E4351B-04A

S E R V I C E N O T E

E4351B SOLAR ARRAY SIMULATOR, 0-120 VDC, 4 A., 480 W GPIB

The Peak to Peak Ripple & Noise at 20 kHz, when operated as a Solar Array Simulator is Out of specification.

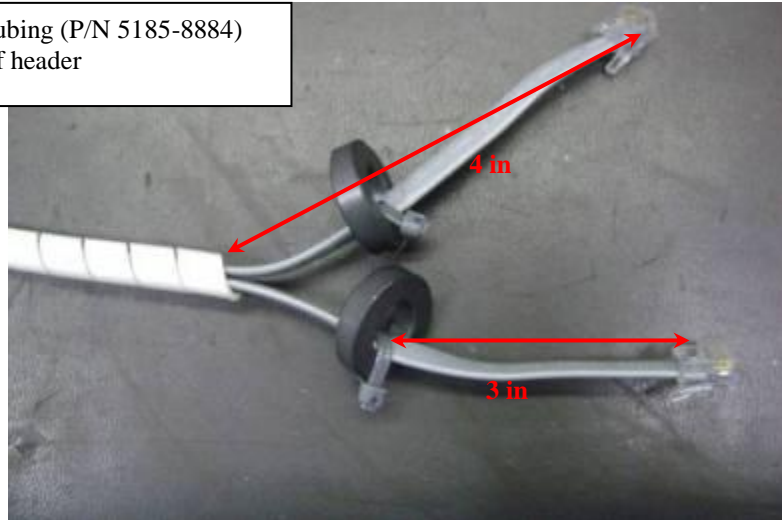
- 1) Place cores (P/N 9170-1497) on 2 short phone cables (06652-80010)

and 2 long phone cables (06652-80011)

- 2) Secure the core to the 4 phone cables with a cable tie (P/N1400-3203)
- 3) Wrap a piece of 9 inch Spiral Wrap Tubing (P/N 5185-8884) around phone cables (P/N 06652-80011)

Start Spiral Wrap Tubing (P/N 5185-8884)
4 inches from end of header

Place phone cable through core 3 inches from end of header
and tie rap exactly as shown

Figure 5

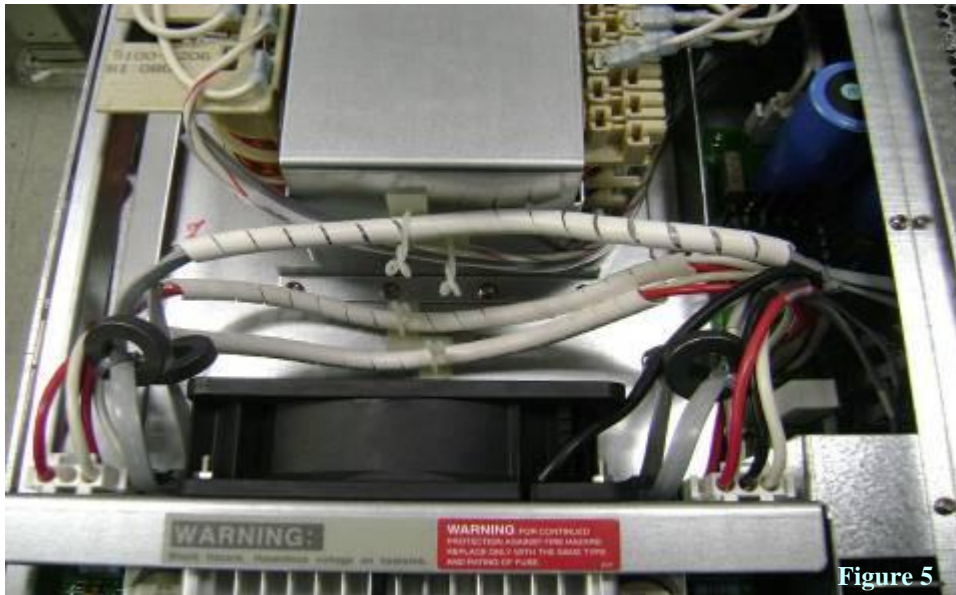
- 1) Secure the cable with cable clip (P/N1400-1281) as shown in figure 5.

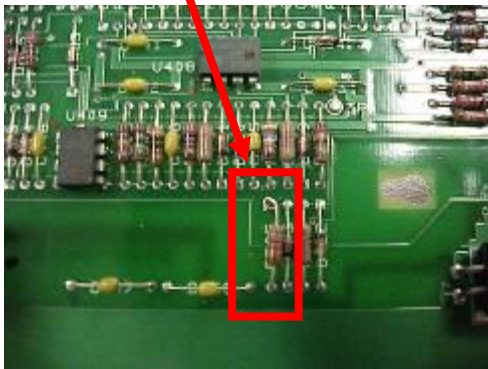
- 5) Bend one end of R800 PN 0699-8987 to a right angle on the other end add a black 22AWG wire PN 8150-3483. The wire should be 174mm long and both ends should be stripped 5mm. Attached the wire with a good mechanical connection.

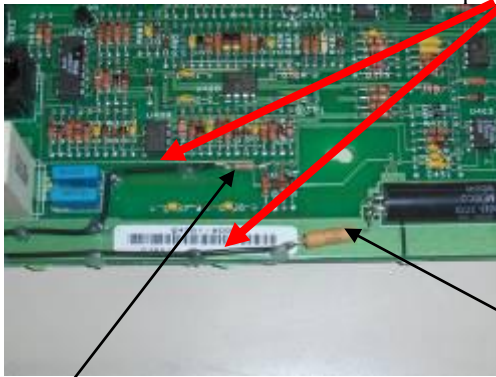
- 6) Desolder R505 and put a loop so R800 can be inserted into the PCB.
 - a. OR Wrap the lead of R800 around the correct side of R505.

Note: Secure the added wire to PCB with epoxy or hot melt glue.

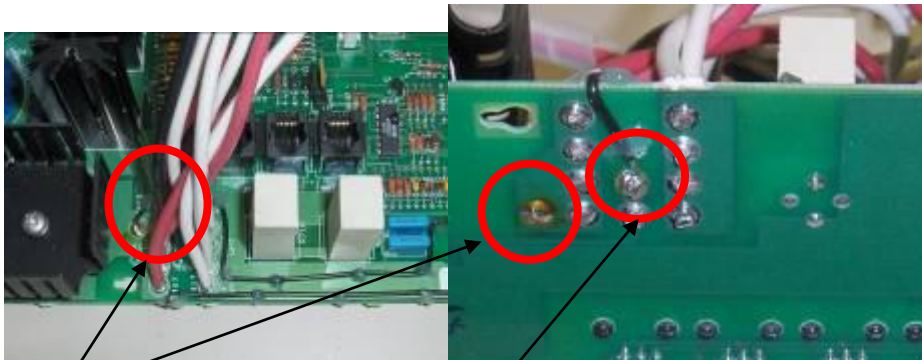
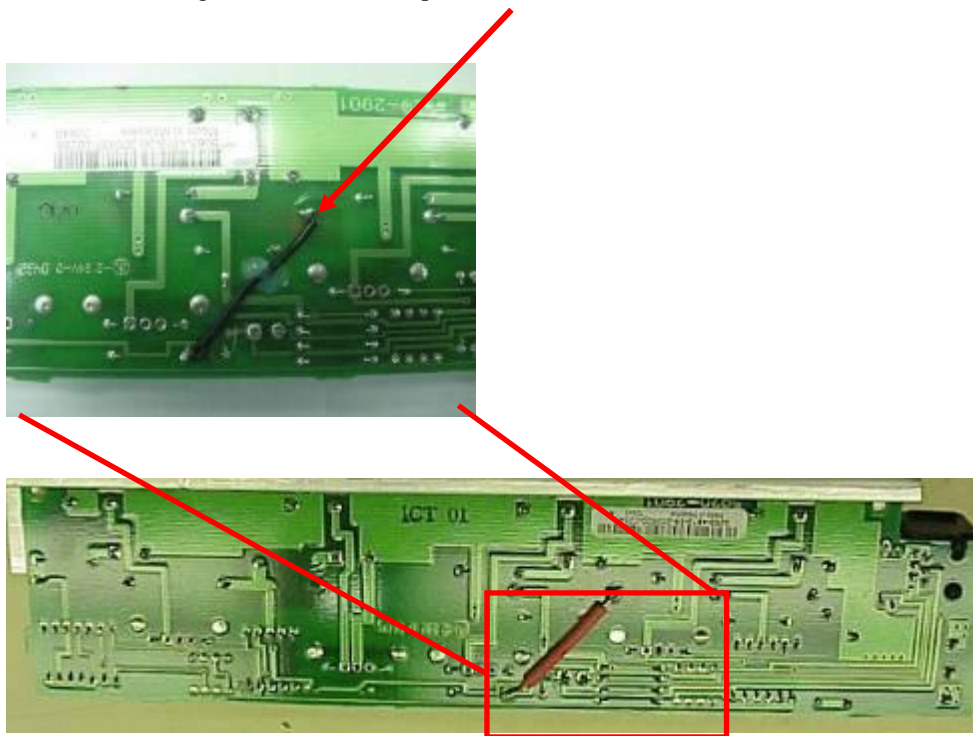
R801 p/n depends on model

R800

E403

E412 (Blk wire)

- 7) R801 is to be added with the value as indicated for each model in the below listing.
- 8) R801 will be added from + OUT Inboard to –Rail.
The resistor values are as follows:

a. E4351B PCB PN E4351-60021 R801 15K ohm P/N 0699-8986

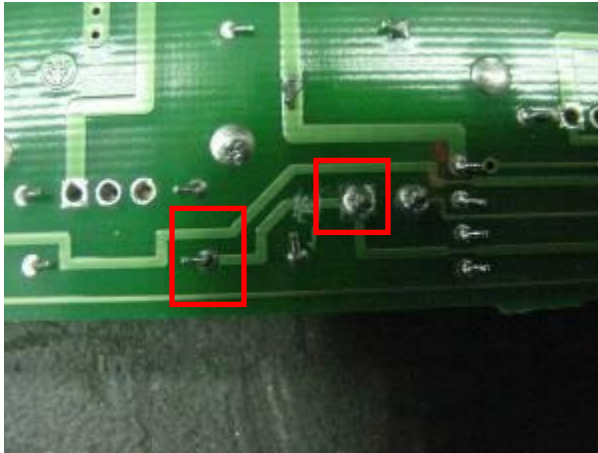
- 1. Figure below shows right tunnel assemble P/N 5063-4815 PCA ready for rework, for a REV A2 PCB P/N 5020-2901.
- 2. Remove ground wire from Capacitor C305 to minus side of source resistor R306.

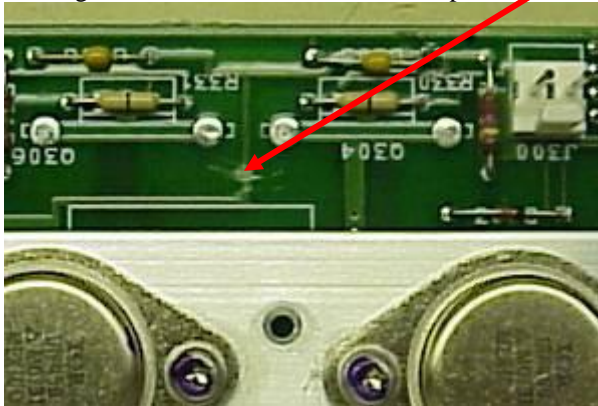
- 3. Add ground wire 22 AWG by wrapping and soldering wire from minus side of Capacitor C305 to pin one of J300.

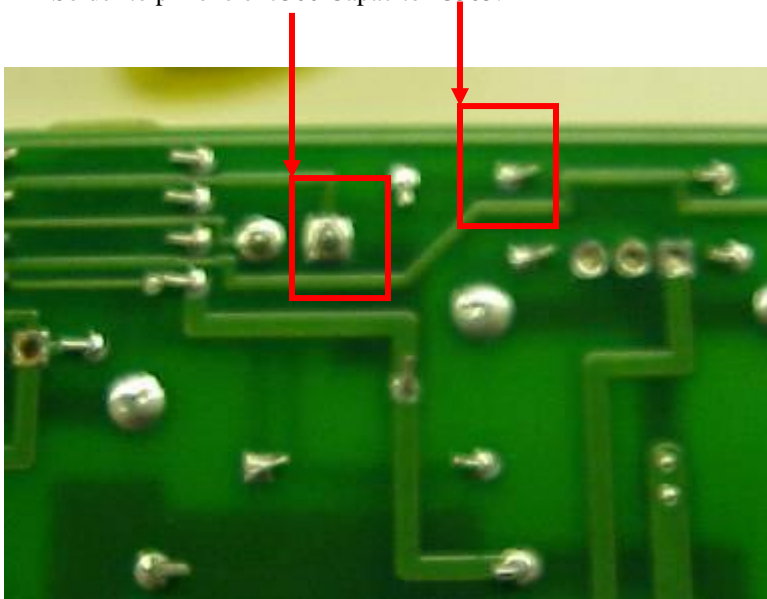
6. Cut ground tract from minus side of Capacitor C305 to minus side of source resistor R306.

8. Add ground wire 22 AWG by wrapping and soldering wire from minus side of Solder to pin one of J300 Capacitor C305.

9. PCA with wire added modification for right tunnel assembly PN 5063-4815 for PCB 5020-2901 REV B completed.
